**FILE NUMBER:** Z234-110(LC)                      **DATE FILED:** October 19, 2023

**REQUEST:** An application for **(1)** a new Planned Development District for R-1ac(A) Single Family District uses; and **(2)** the termination of Specific Use Permit No. 580 for a private school with consideration for a Specific Use Permit for a private school on property zoned an R-1ac(A) Single Family District.

**SUMMARY:** The purpose of the request is to allow modified development standards primarily related to uses, setbacks, floor area, height, lot coverage, parking, and fencing to allow a private school.

### CPC RECOMMENDED DEVELOPMENT PLAN (ENLARGED)

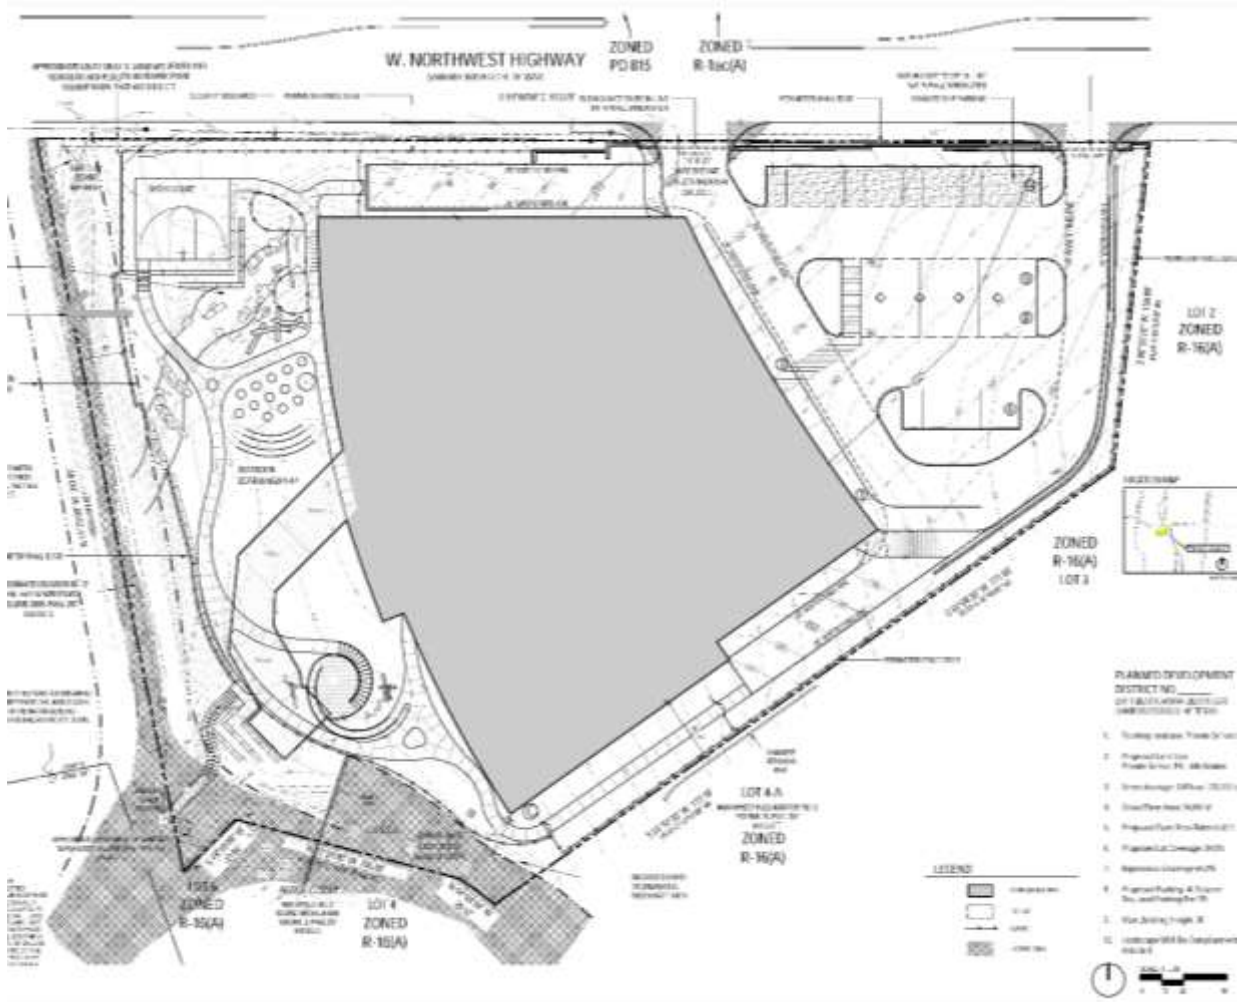
The submitted development plan design has a proposed sports court in the northwest corner of the site and the proposed parking lot is in the northeast corner of the site. An 8-foot fence runs the length of the front entrance section of the property. Therefore, the applicant is requesting a new planned development for the following reasons:

1. Relief from front yard setback from 40-feet to 20-feet to accommodate the school building and any playgrounds/sports courts. Allowance of significant encroachments to the reduced front yard, including a row of parking and the sports court.
2. Relief from rear and side yard setbacks from 20-feet to 10-feet. Encroachments such as awnings, balconies, bay windows, ramps, retaining walls, stairs, stoops, and unenclosed porches are allowed into the required side and rear yards and do not need to be shown on the development plan.
3. Allowance for parking within the front yard setback.
4. Allowance to install an 8-foot fence and a security gate within the front yard setback.
5. Securing zoning entitlements for a permanent time-period, rather than risking a more limited time period with an SUP.

According to Dallas Development Code these elements are not permitted. The existing zoning district of the subject site is an R-1ac(A) Single Family District. The sports court is categorized as an accessory use, and those are not allowed in the front yard setback of the existing zoning district. Structures also must not be in the front yard setback of the property. Therefore, the applicant is requesting to create a new planned development in order to deviate from code.

Staff finds the applicant's justification for deviating from the development code to be insufficient from a land use and zoning lens. Additionally, the deviations requested can be addressed by using other methods to be in closer compliance with the development code. One method is through a Specific Use Permit with a ten-year period.

**Motion:** It was moved to recommend 1) **approval** of a Planned Development District, subject to a revised development plan and conditions, with the following changes (1) Yard, Lot, and Space Regulations Section: Sec 51P.108 (b) 1 - change first sentence to read, "Except as provided in this paragraph, minimum side yard is 10 feet. Along Devonshire Drive, minimum side yard is 30 feet."; Sec 51P.108 (b) 3- change to read, "For a private school, maximum structure height is 30 feet." (2) Off Street Parking and Loading Section: Sec 51P. 109 (b) 1 - change to read, "Off-street parking and loading for a private school is a minimum of 44 spaces."; Add Sec 51P. 109 (b) 2-Overnight storage of full-size buses or trailers greater than 35 feet in length is prohibited. (3) Landscaping and Tree Preservation Section: Accept Staff's recommended conditions as set forth in the boxed conditions on page 15-17 of the briefing which reads: Sec 51P. 111 (a) - Except as provided in this section, landscaping and tree preservation, removal and replacement must be provided in accordance with Article X of the Dallas Development Code, as amended. Sec 51P. 111 (b) Plant materials must be maintained in a healthy, growing condition. Item 1 - In the required residential buffer zone, the building official may approve two small trees to be substituted for each large or medium tree. Item 2 -An enhanced street buffer zone is required and must include the following: (a) From the frontage inward, 3 feet of groundcover, 3 feet of rows of perennial plantings approved by the director at a spacing of no more than 3 feet, and 4 feet of shrub plantings approved by the director at a spacing of no more than 6 feet with a minimum height of 4 feet.; (b) No fences may be located within this zone.; Add Item C. Fifteen 20-foot trees shall be planted along the shared property line with Devonshire Drive as specified in the Development Plan. (4) Fencing Section: Add Sec 51P. 112.1A(c) -A 9-foot board-on-board fence is required along the Devonshire property line.; Add Sec 51(P). 112.1A(d) - Along the creek in the southeast corner, a 4-foot open metal or picket fence is required. (5) Outdoor Lighting: Add new section - Outdoor Lighting: (a) All outdoor lighting, where permitted, must be hooded, directed downward and away from adjacent properties to minimize spillage. (6) Signs: Add a new subsection to 51(p).112.; (b) The only illuminated sign permitted is along Northwest Highway; and 2) **approval** of the termination of SUP No. 580, on property zoned an R-1ac(A) Single Family District, on the south side of the intersection of West-Northwest Highway and Meadowbrook Drive.

### STAFF'S RECOMMENDED SUP SITE PLAN (ENLARGED)

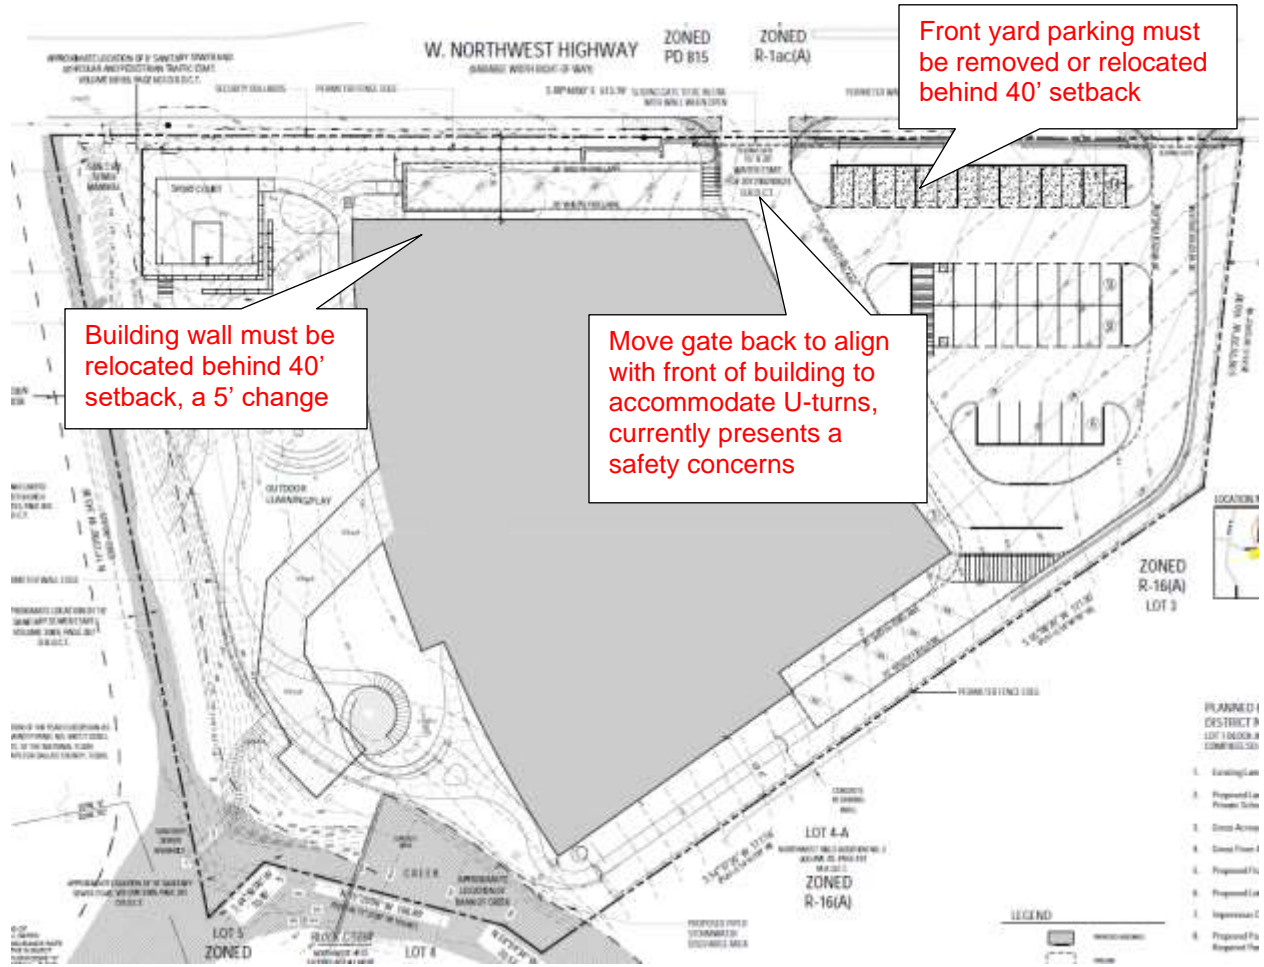
To operate under an SUP, the applicant would need only make minor adjustments to the site plan, including:

1. Shifting the front building façade south by about 5 feet to accommodate the front yard.
2. Remove parking from the front yard, required parking for institutional uses can be addressed through an SUP if necessary.

Other revisions using the PD are likely not necessary, the buildings comply with the side and rear setbacks and the horizontal portions of the sport court can be located within the setback given, vertical elements are behind the setback line. The fence height adjustment
